NL-11-1128

Vogtle Electric Generating Plant, Units 1 and 2
License Amendment Request to Revise
Technical Specification 3.7.9 Ultimate Heat Sink (UHS)

**Vogtle Electric Generating Plant, Units 1 and 2
License Amendment Request to Revise
Technical Specification 3.7.9 Ultimate Heat Sink (UHS)**

Figure 3.7.9-1
Required Number of Fans/Spray Cells

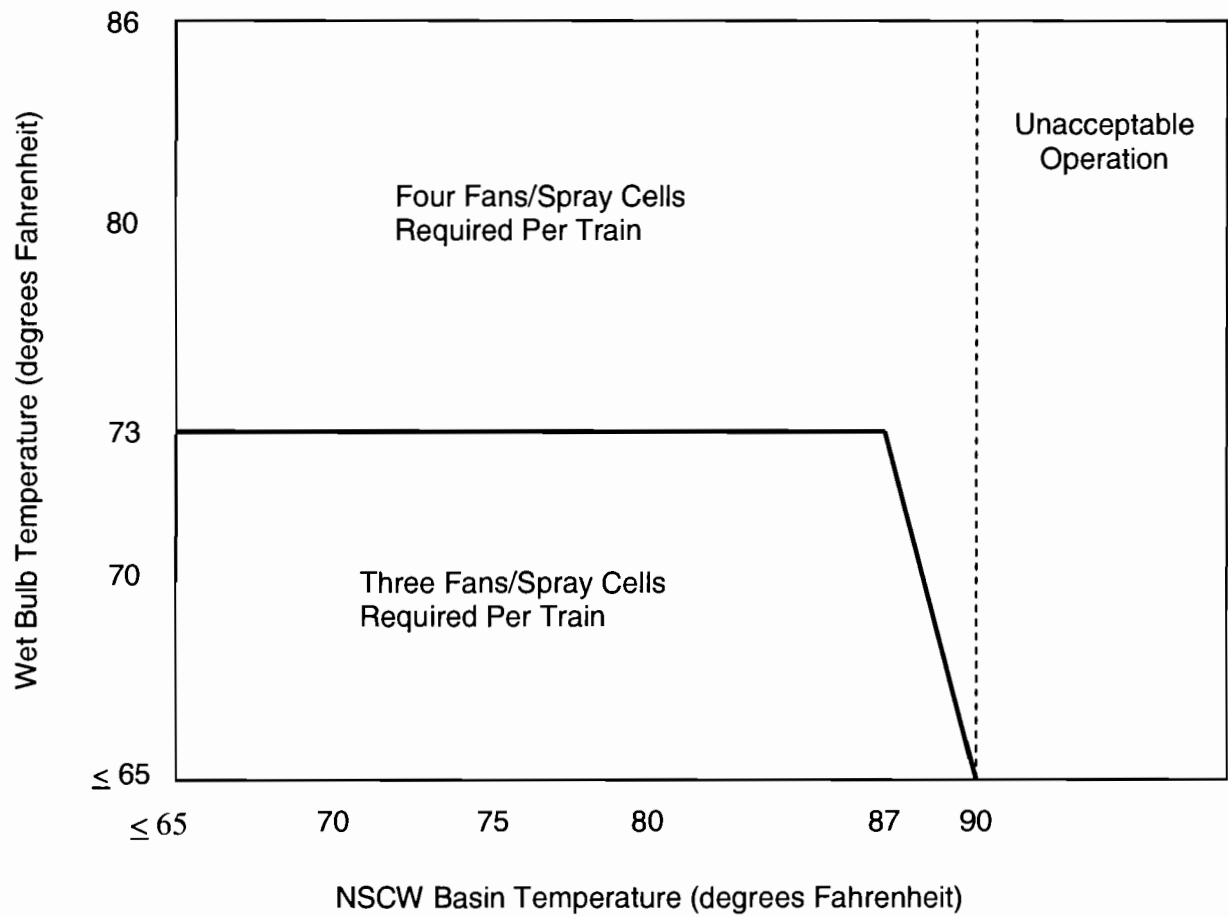
The proposed changes to the TS involve increasing the NSCW wet bulb temperature limit from 63°F for three fan/four spray cell operation to the limits indicated in proposed TS Figure 3.7.9-1 for three fan/three spray cell operation, and adding a Condition that allows a seven-day Completion Time for a specific situation.

Requirement 3 will be changed such that the necessary number of operating fans/spray cells will be dependent on the wet bulb temperature and basin temperature relationship indicated in the proposed TS Figure 3.7.9-1. As indicated by the proposed TS Figure 3.7.9-1, for a basin temperature $\leq 87^\circ\text{F}$, four fan/spray

B. One NSCW cooling tower with one required fan/spray cell inoperable when operating in four fan/spray cell required region of Figure 3.7.9-1.	B.1 Restore fan to OPERABLE status.	7 days
--	-------------------------------------	--------

is within the three fan/spray cell region of Figure 3.7.9-1

The wet bulb temperature limit change is supported by an engineering calculation (Enclosure 5). That calculation confirms, for wet bulb temperatures in the three fan/spray cell region of the proposed TS Figure 3.7.9-1, three fans/spray cells are adequate to maintain the basin water temperature within required limits for LOSP and LOCA, the worst case heat loads of the UHS. This calculation does not account for any heat loss to the atmosphere via natural draft cooling effect of the out-of-service fan and spray cell. The input to the computer model uses zero air flow to the out-of-service spray cell which results in no cooling of the return flow to this spray cell. This NSCW return flow heat is added directly to the basin and accounted for in the increased basin temperature.
